Dunkin

Donuts/Valvoline

20290 GRANDE OAK SHOPPES BOULEVARD

# Site Plan

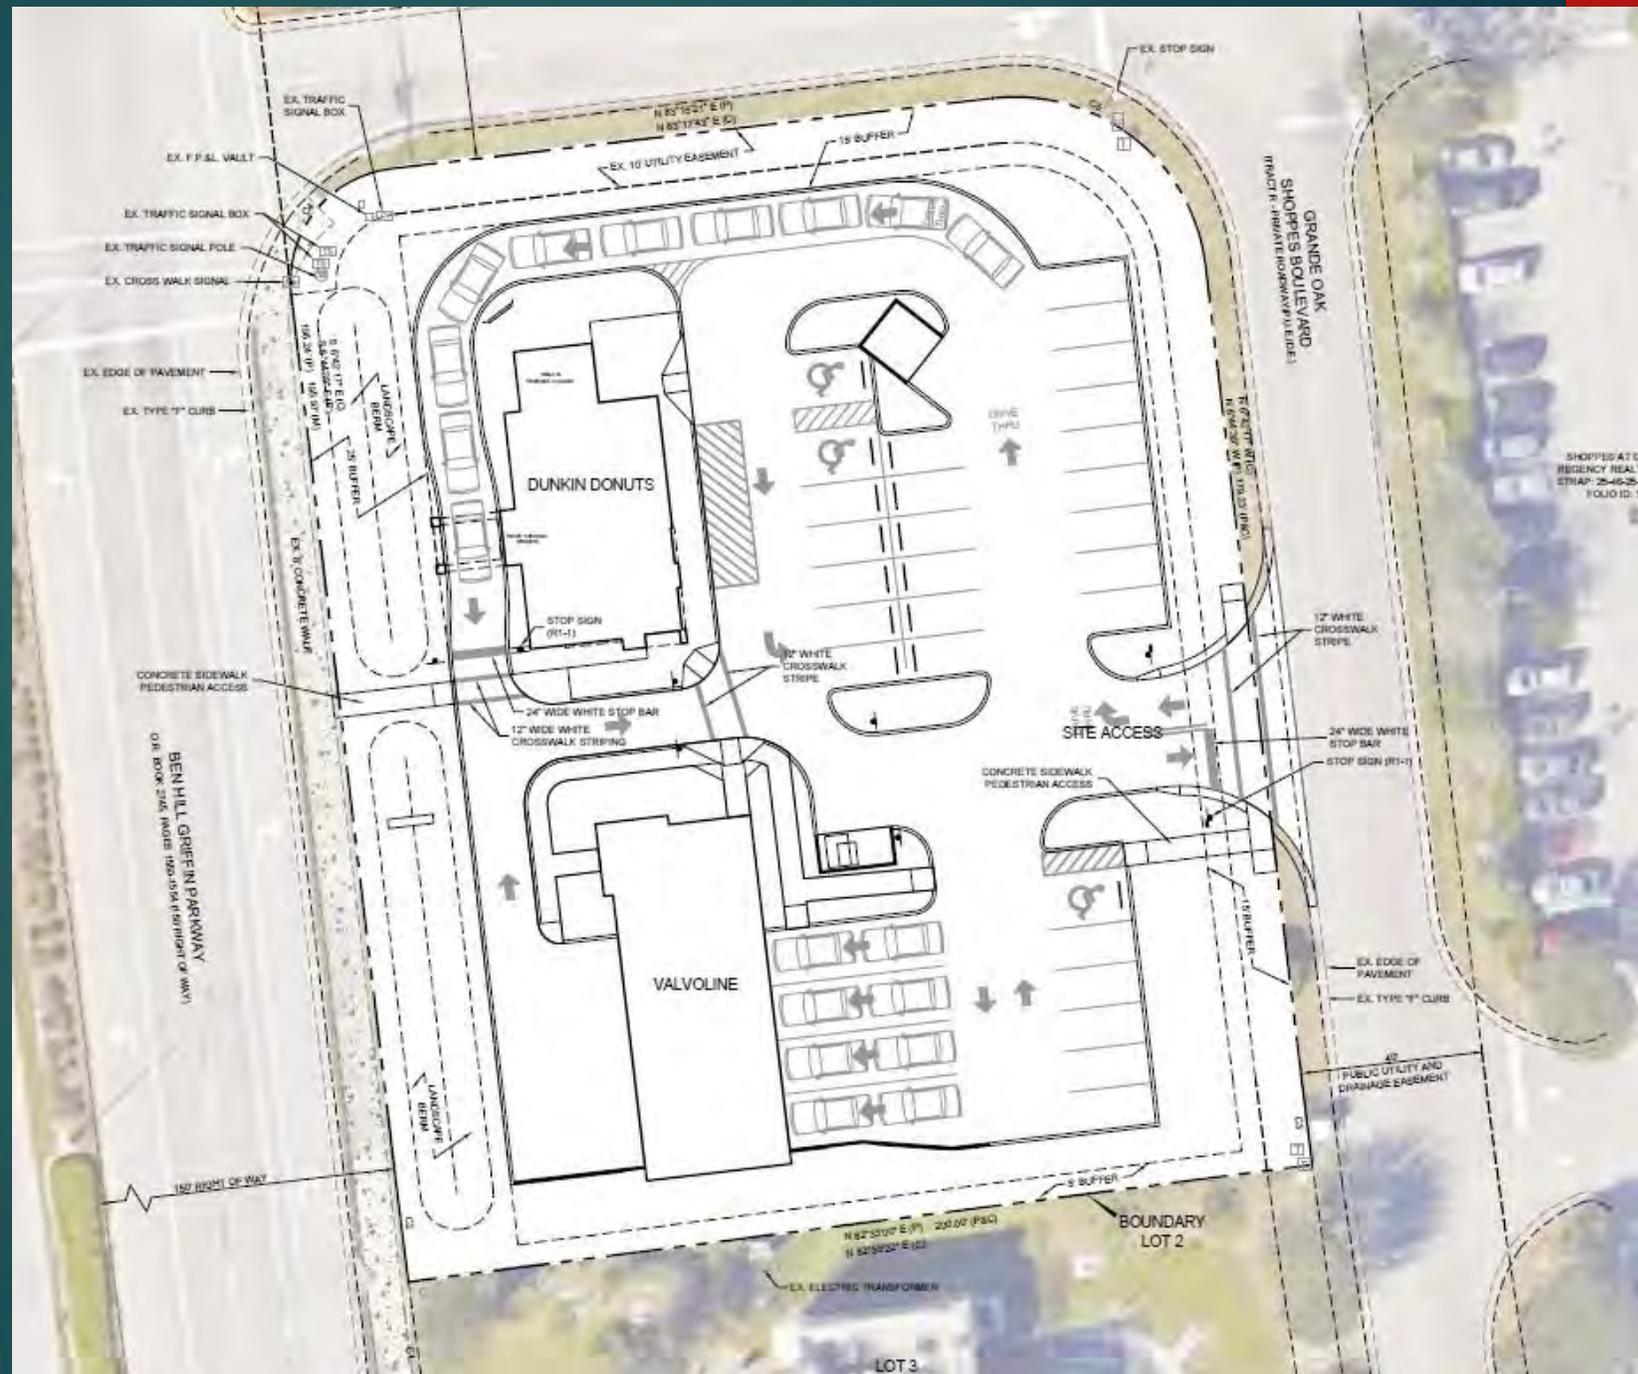
# Site Plan Changes Since Last DRB

- ▶ Pulled sidewalk away from buildings to provide room for additional foundation landscaping
- ▶ Added sidewalk connection to east onto Grande Oak Shoppes Boulevard
- ▶ Added crosswalk between Dunkin Donuts and Valvoline

# Dunkin Donuts Elevations

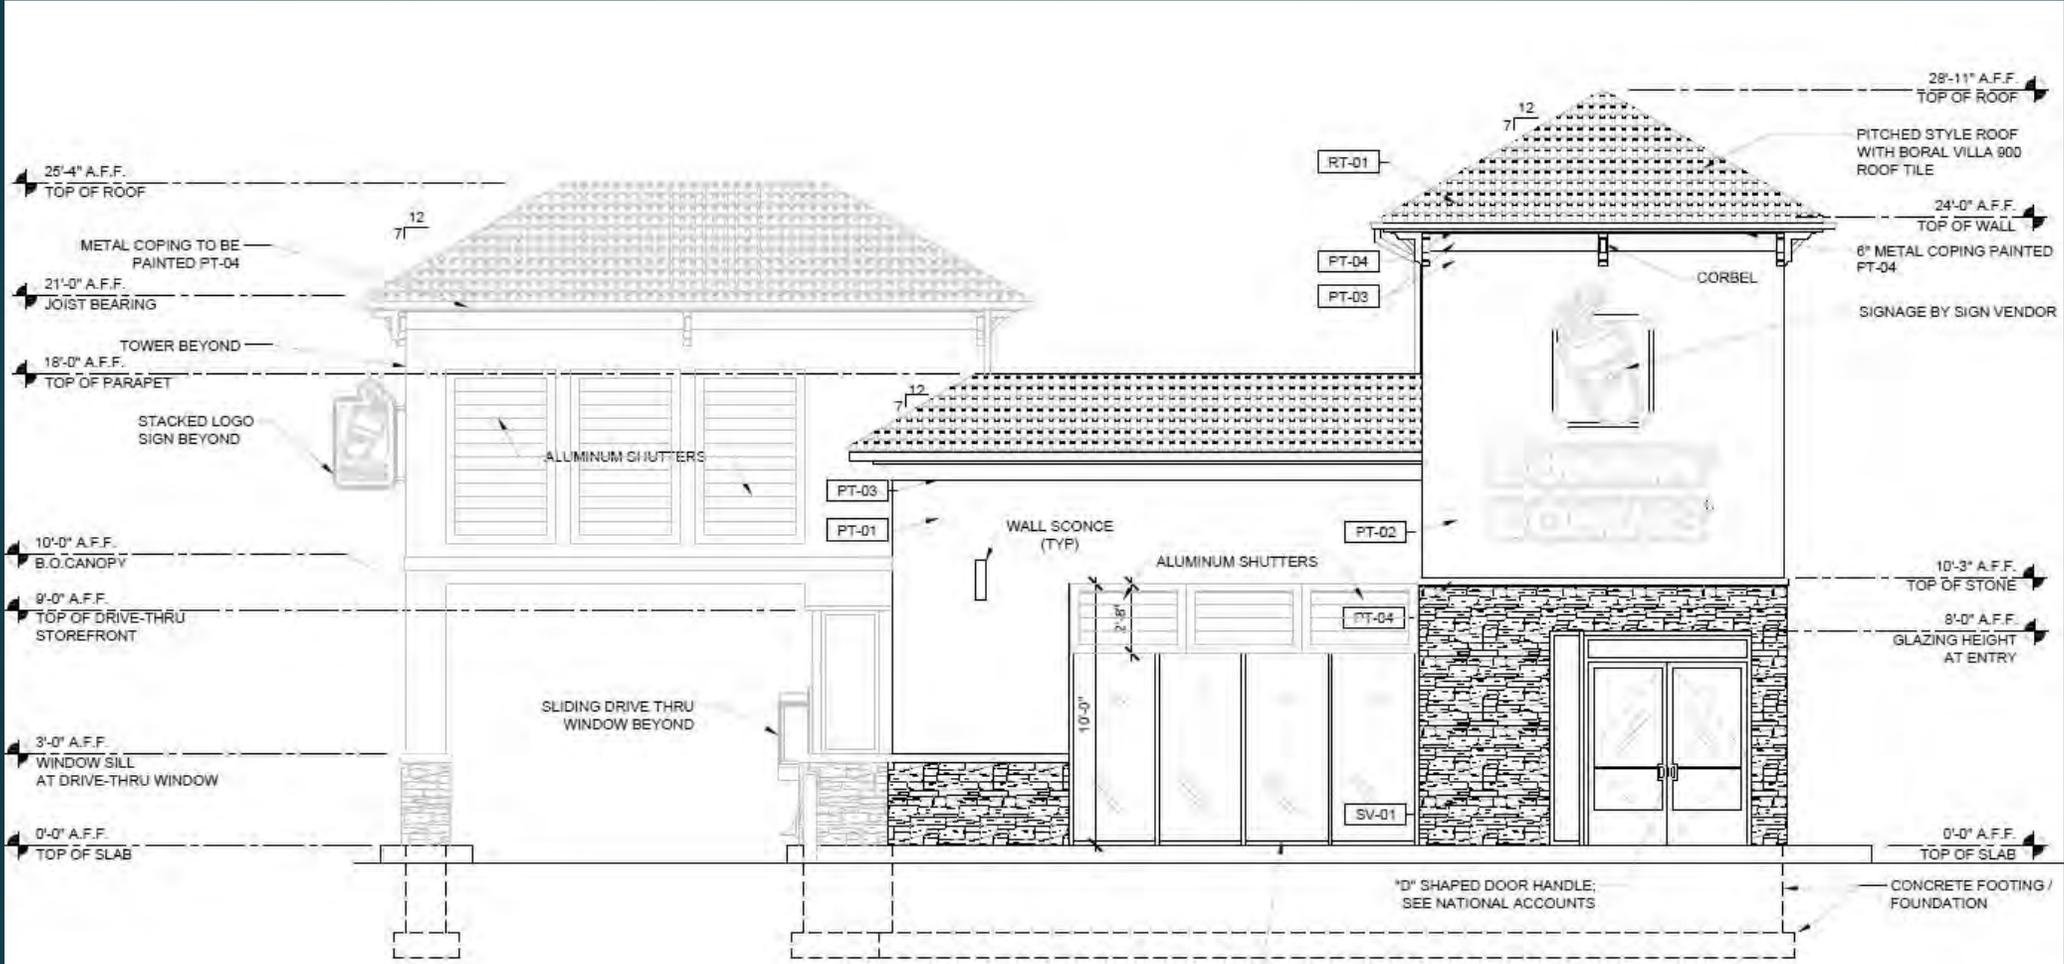
# Dunkin Donuts Building Changes Since Last DRB

- ▶ Raised main entry tower to create hierarchy
- ▶ Extended drive-thru tower over drive-thru lane
- ▶ Added faux windows and additional trim to side elevation
- ▶ Enclosed mansard roof and provided additional landscape planting to create more of a presence at rear façade.
